# TECHNICAL BULLETIN TR-18

DATE: DECEMBER 19, 2003  
 MODEL YEAR: 1992 AND AFTER  
 TRANSMISSION MODEL: MLS61B  
 BULLETIN NUMBER: TR-18  
 FILE IN THE TRANSMISSION SECTION OF THE TECHNICAL BULLETIN BINDER

## MLS61B COUNTERSHAFT CHANGE

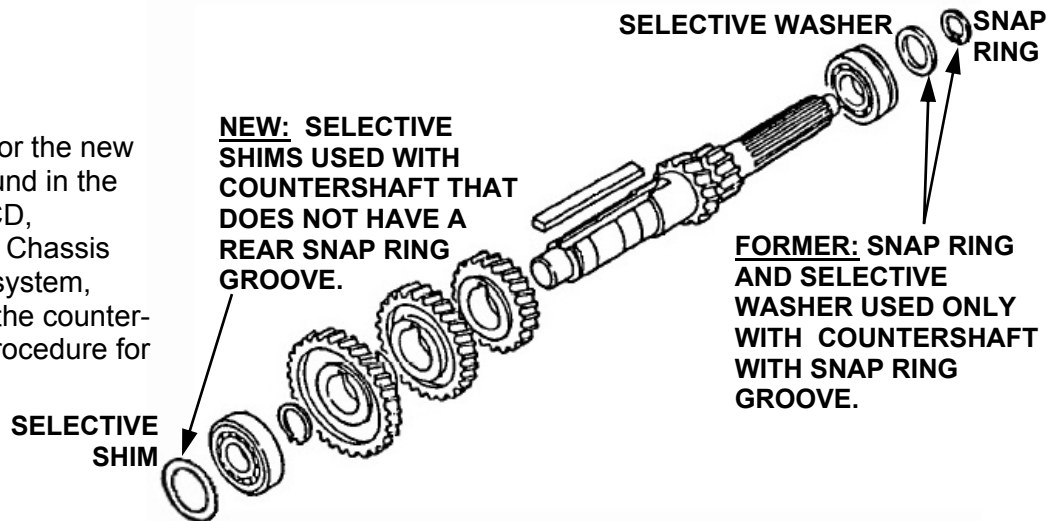
The countershaft rear bearing snap ring and selective spacer has been eliminated starting with MLS61B transmissions produced in March 2002.

The new countershaft does not have a rear snap ring groove and utilizes selective shims between the front bearing and clutch housing. This is a similar countershaft design that is used in the MLS62B transmission.

Assembly procedures for the new countershaft can be found in the 2004 Service Manual CD, UD1800HD ~ UD3300, Chassis section, Transmission system, page TM1-5-23, using the countershaft endplay setting procedure for the MLS62B.

### PARTS NOTICE

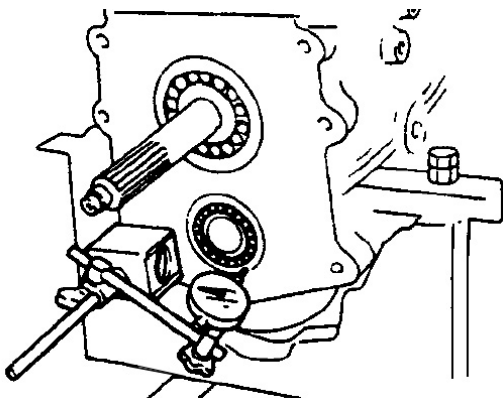
The following shim part numbers should be used to set the proper countershaft end play.

SHIM PART NUMBER	SHIM THICKNESS, mm (in)
32218Z5000	0.1 (0.004)
32218Z5001	0.2 (0.008)
32218Z5002	0.3 (0.012)

**SPECIAL NOTE:** Although the MLS61B and MLS62B countershaft appear similar, they are not interchangeable.
